**ANNOTATED  
AGENDA  
CITY OF ANTIOCH PLANNING COMMISSION  
ANTIOCH COUNCIL CHAMBERS  
THIRD & "H" STREETS**

**WEDNESDAY, MAY 6, 2015**

2. **UP-14-14, V-15-01, AR-14-08 TACO BELL** – Taco Bell requests approval of a Use Permit for a 1,822 square foot fast food restaurant with a drive-thru; a Variance to reduce the A Street and 18<sup>th</sup> Street setbacks; a Variance to modify parking standards; and Architectural Review. The project site contains an existing 3,200 square foot building which will be demolished. The project site is located at 1706 A Street (APN 067-243-031).

**STAFF REPORT TO THE PLANNING COMMISSION  
FOR CONSIDERATION AT THE MEETING OF MAY 6, 2015**

FLOOR PLAN 1/4" = 1'-0" A

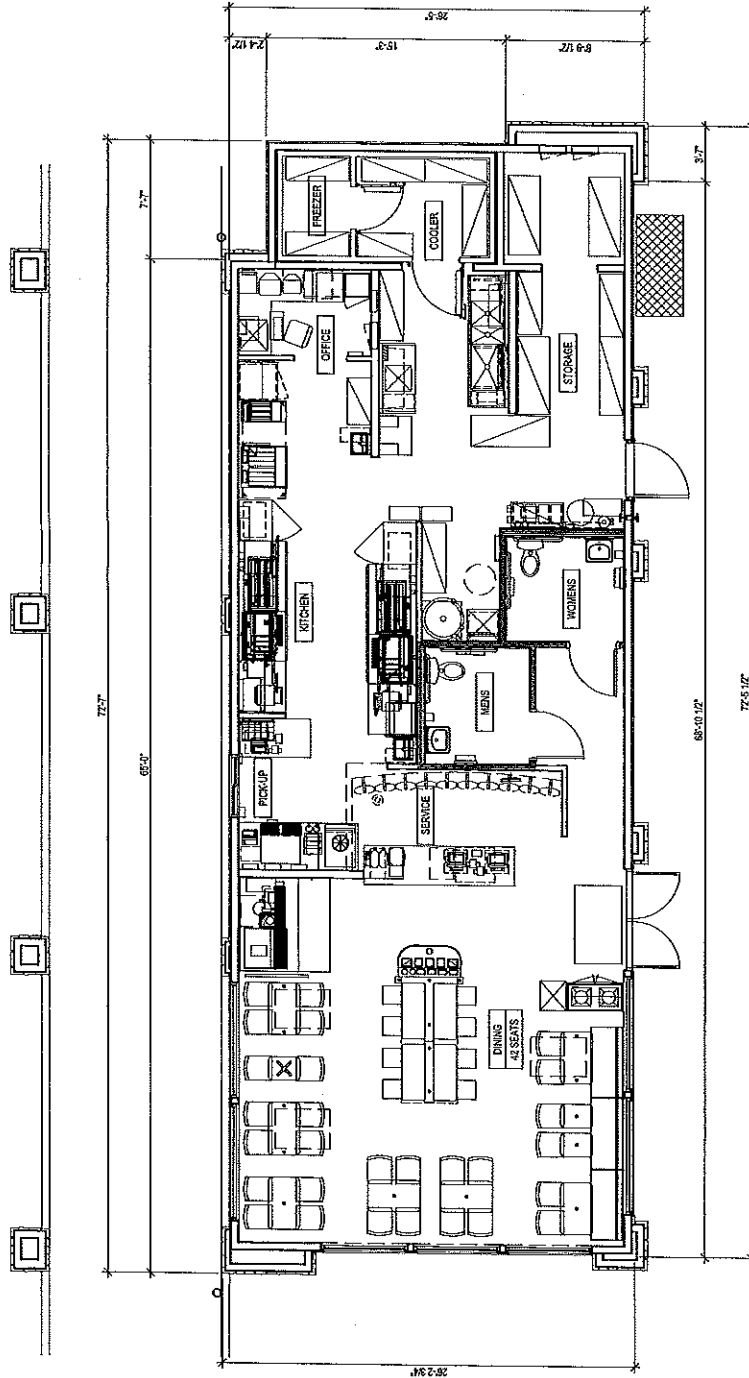
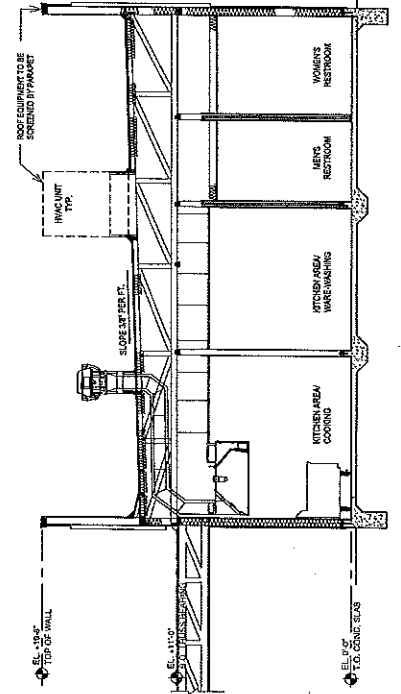
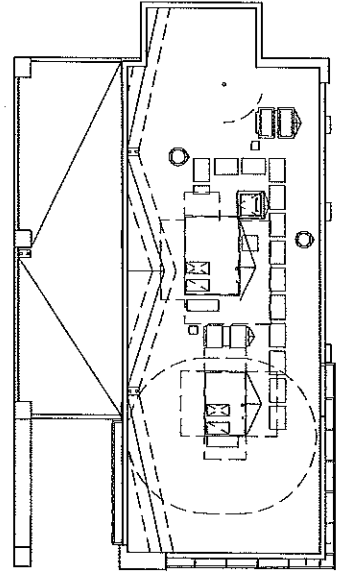
15	Site Plan	Parking	Parking Data doesn't match plan
	<b>BUILDING PLANS DD2,4, 4.1 AND DD5</b>		
16	DD2 Floor & Roof Plan	Floor Plan-Coordination	Add the electrical cabinet on the entry side of the building. Match roof plan to floor plan.
17	DD4.0 North Elevation	Commercial Design Guidelines 3.1.5 Storefront	<p>The elevation on the storefront side is prioritized with specific elements that are in conflict. Storefront entry is not emphasized and doesn't have any overhang to protect customers with a sheltered transition area into the interior, while the service door does, emphasizing that door. Removing pilaster and slats at electrical cabinet and loading door could help with focusing the enhancements of the customer area. Aligning the roof line breaks with the entry doors and adding reveals can create a more organized front elevation. Adding stone base below the storefront will help tie together the vertical lines of the elevations more and visually lower the parapet.</p> <p>Add a light fixture to the end corner stone pylon to match the other fixtures.</p>

19	Floor Plan	City Design Guidelines 3.2.28 Drive Through Businesses and Pedestrian Connections	Consider reversing the location of entry/front elevation and drive through to create better street and building definition.
20	DD4.1 Elevations	Commercial Design Guidelines 3.1.5 Storefront	<p>The following suggestions are made to improve the overall appearance of the building:</p> <p>South elevation-Add stone veneer under the windows. The rear lower wall panel color should match the darker color (Rookwood Clay) shown on the west elevation. Horizontal score lines in wall facade should align with the top of the pylon. Vertical score lines should "bracket" the pylon edges for all the stone pylons seen in this elevation.</p> <p>All elevations-Study the overall height of the building, which seems tall in proportion to the small size of the building-19' for the top of the parapet and over 20' for the stone veneer pylon in the west elevation.</p> <p>East Elevation-add stone veneer under the windows. Add bell to color rendered elevation to match B&amp;W elevation.</p> <p>West Elevation- Plaster scoring should align with the top of the shorter pylon.</p>
